GNRO-2014/00069

**SUBJECT:** Revised Response to Items 1 and 2 of the Request for Additional Information Regarding "Maximum Extended Load Line Limit Plus" Amendment Request, dated 5/19/2014.  
Grand Gulf Nuclear Station, Unit 1  
Docket No. 50-416  
License No. NPF-29

**REVISED RESPONSE TO ITEM 1 AND ITEM 2 REQUEST FOR ADDITIONAL  
INFORMATION DATED 5/19/2014 PERTAINING TO LICENSE AMENDMENT REQUEST –  
MAXIMUM EXTENDED LOAD LINE LIMIT PLUS**

**Figure 1.1. Graphical Depiction of the SLMCPR Evaluation Statepoints**

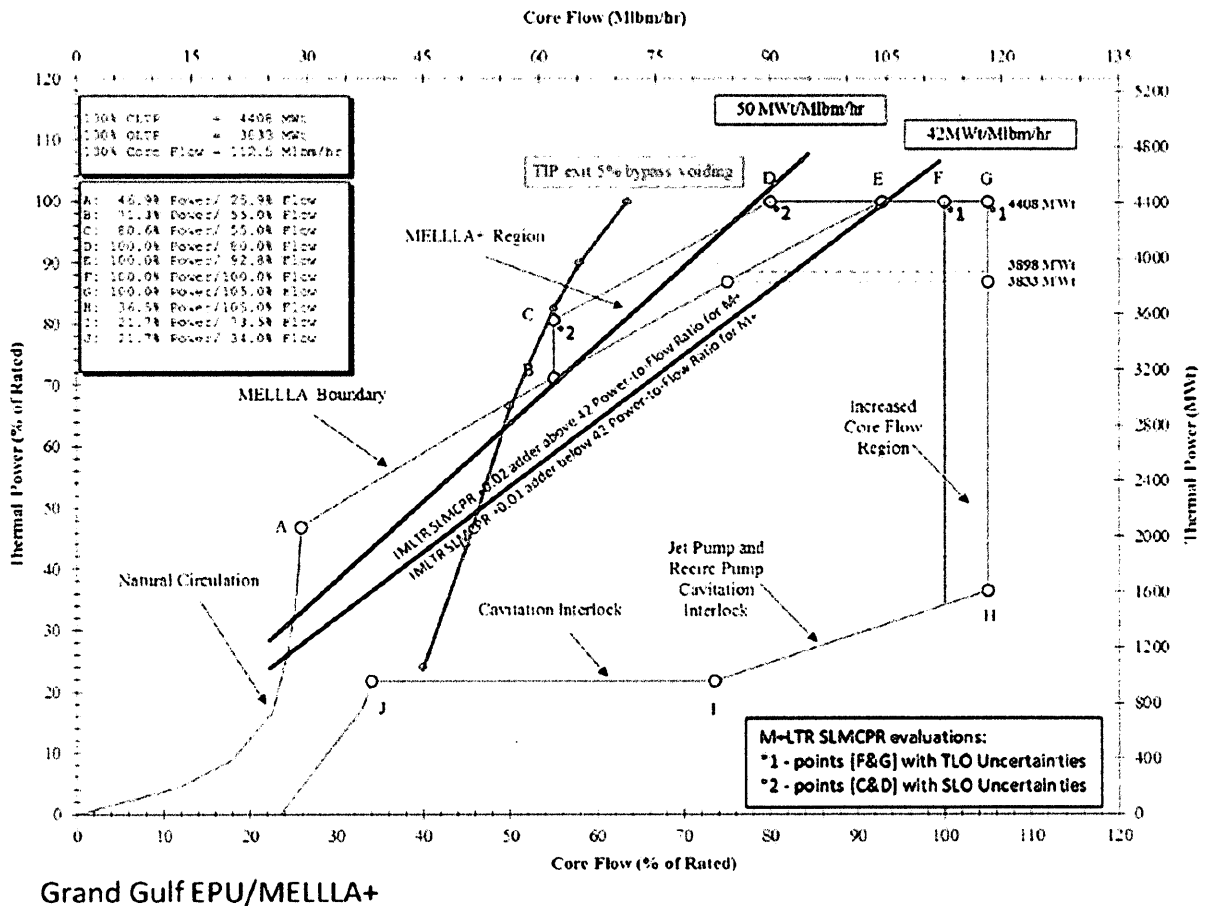
Section 2.2.1 “Safety Limit Minimum Critical Power Ratio” states that “The currently approved off-Rated Core flow (CF) uncertainty applied to the Single Loop Operation (SLO) is used for the minimum CF statepoint D and at 55.0% of CF statepoint C.” Section 2.2.5 “Power-to-Flow Ratio” states that statepoint C has a power density of 57.42 Megawatts Thermal/Million Pounds/Hour (MWt/Mlbm/hr), which is larger than the MELLLA+ Licensed Topical Report (LTR) limit of 50 MWt/Mlbm/hr, and states “this limitation is resolved in the near-term by applying additional conservatism to the cycle-Specific Safety Limit Minimum Critical Power Ratio (SLMCPR).” This “additional conservatism” is not documented in Section 2.2.5 of the Safety Analysis Report (SAR). Provide:

1. Definition of the “additional conservatism” method.
2. A numerical example of the application of this conservatism.
3. A justification that the power distribution uncertainties at the higher power density are covered by the proposed method.

The additional conservatism is included by incorporation of the +0.02 Safety Limit Minimum Critical Power Ratio (SLMCPR) adder specified by the Methods LTR SER Limitation and Condition 9.5 (Reference 1-1) for MELLLA+ plants with planned operation above a Power-to-Flow Ratio of 42 MWt/Mlbm/hr.

It should also be noted that the SLMCPR evaluation specified by the MELLLA+ LTR Safety Evaluation Report (SER) Limitation and Condition 12.6 (Reference 1-2) specifically requires an evaluation of the Two Loop Operation (TLO) SLMCPR using the highest NRC-approved core flow uncertainties (i.e. SLO uncertainties) at the off-rated condition that has the highest Power-to-Flow Ratio in the MELLLA+ operating domain.

Therefore, additional conservatism and justification that the power distribution uncertainties are acceptable is based on inclusion of the following:

- +0.02 SLMPCR adder for Power-to-Flow Ratio >42 MWt/Mlbm/hr,
- TLO SLMCPR evaluation at statepoint C (P-to-F = 57.42), and
- TLO SLMCPR evaluation with SLO uncertainties.

SLO is not allowed in the MELLLA+ operating domain, but the SLO uncertainties are used to evaluate the TLO SLMCPR for required statepoints in the MELLLA+ operating domain. The SLO SLMCPR evaluation will normally be lower than the TLO SLMCPR due to the off-rated evaluation with SLO uncertainties. It is anticipated that MELLLA+ plants will have the TLO SLMCPR and SLO SLMCPR be set equivalent in the technical specifications to avoid a SLO SLMCPR lower than a TLO SLMCPR.

See Figure 1.1 for a graphical depiction of the SLMCPR evaluation statepoints.

**Figure 2.1. Graphical Depiction of the SLMCPR Evaluation Statepoints**

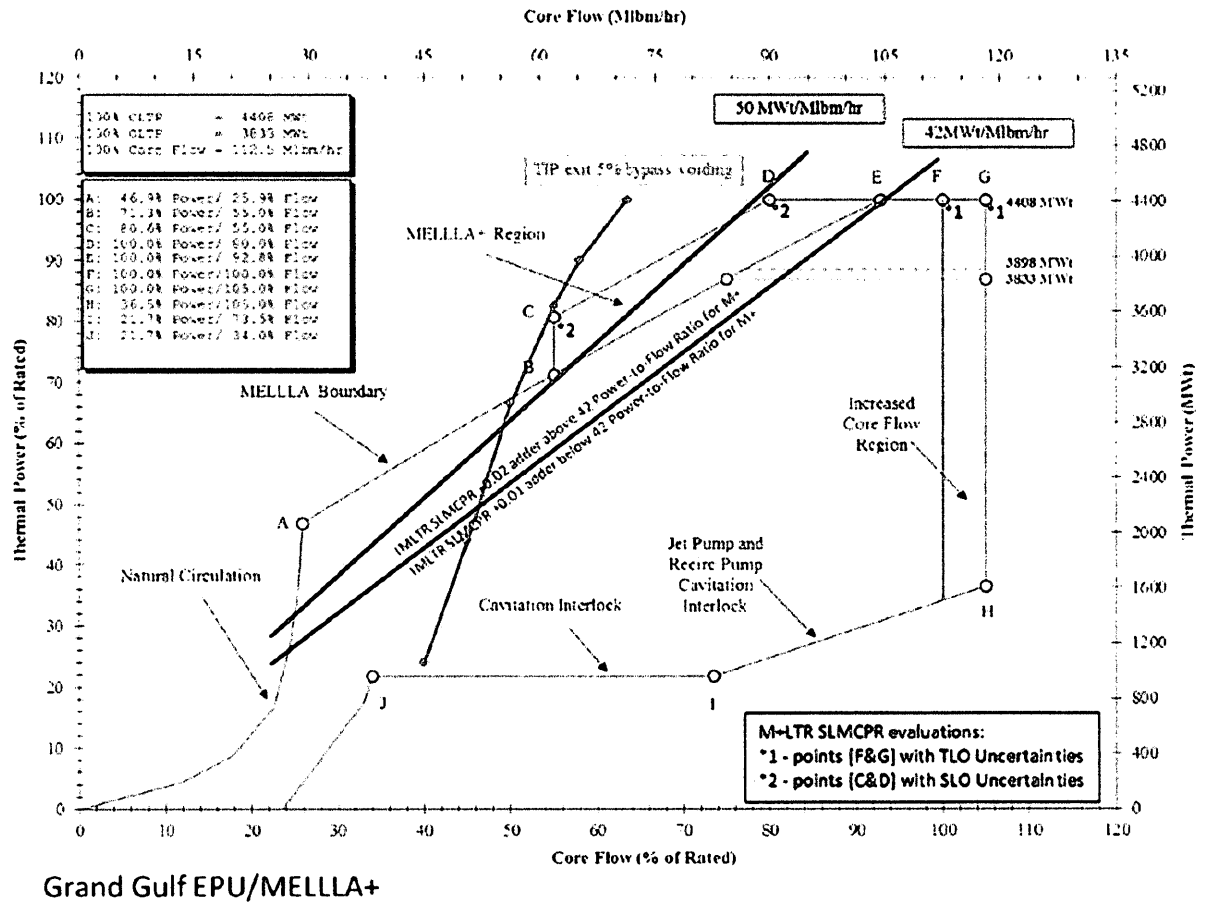
Section 2.2.1 “Safety Limit Minimum Critical Power Ratio” states that “a +0.02 SLMCPR adder will be added to the cycle-specific SLMCPR.”

1. Provide a list of SLMCPR adders in MELLLA+ with respect to Operating Licensed Thermal Power (OLTP) conditions.
2. Specify which adders are part of the Extended Power Uprate (EPU), and which are MELLLA+ specific.

Table 2.1 specifies the applicable Safety Limit Minimum Critical Power Ratio (SLMCPR) adders defined by the Methods LTR SER Limitation and Condition 9.5 (Reference 2-1) for operation with EPU/MELLLA and EPU/MELLLA+.

Figure 2.1 shows a graphical depiction of the SLMCPR evaluation statepoints and the Methods LTR penalties applied based on Power-to-Flow Ratio. Statepoints C&D [\*2] in Figure 2.1 apply a +0.02 SLMCPR adder. Statepoints F&G [\*1] in Figure 2.1 apply a +0.01 SLMCPR adder.

The most limiting SLMCPR of the four evaluation statepoints at BOC/MOC/EOC cycle exposure conditions will be used to set the technical specification SLMCPR. It is anticipated that MELLLA+ plants, will have the TLO SLMCPR and SLO SLMCPR be set equivalent in the technical specifications to avoid a SLO SLMCPR lower than a TLO SLMCPR.
